**SUBSIDENCE REVIEW
– Russell Vale Colliery Residual Matters Report
Independent Peer Review**

REPORT NO: 1407/02.1

DATE: 25th September, 2014

2. REVIEW OF SCT REPORT No. WCRV4263 (18 June, 2014)

Figure 2. (source: SCT Report NRE14123)

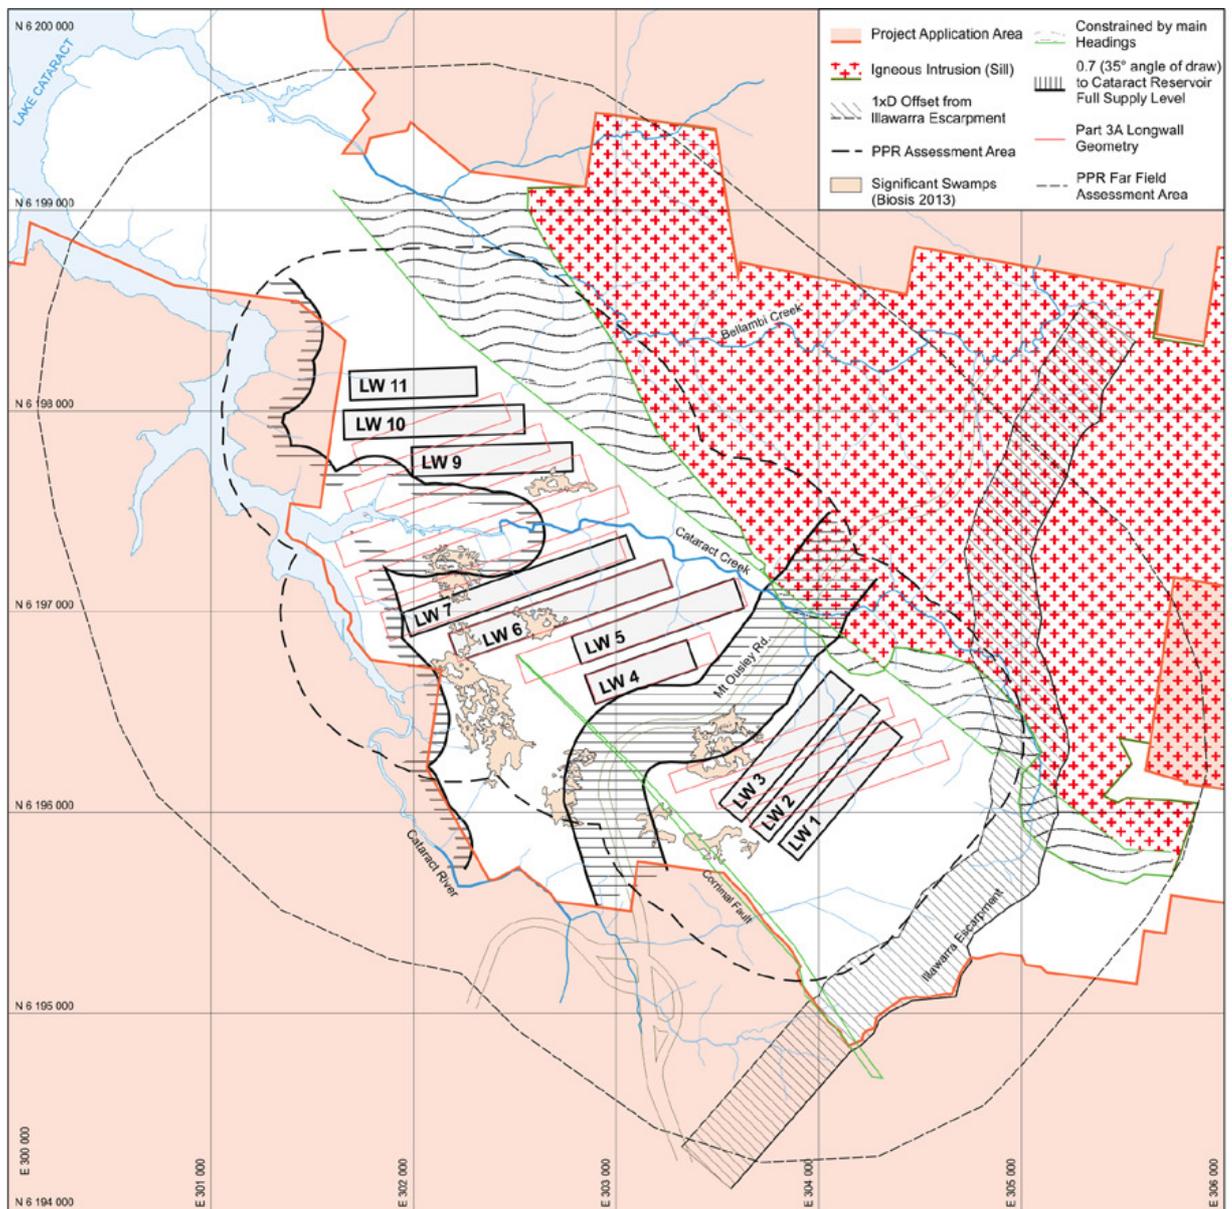
These constraints all seem reasonable and appropriate, however the constraint with respect to the significant upland swamps lacks any quantitative or measurable definition, in terms of how does this translate to a design constraint. Figure 2 is a copy of Figure 2 from the SCT report, showing both original and the revised PPR mine layouts, together with the various constraints identified above.
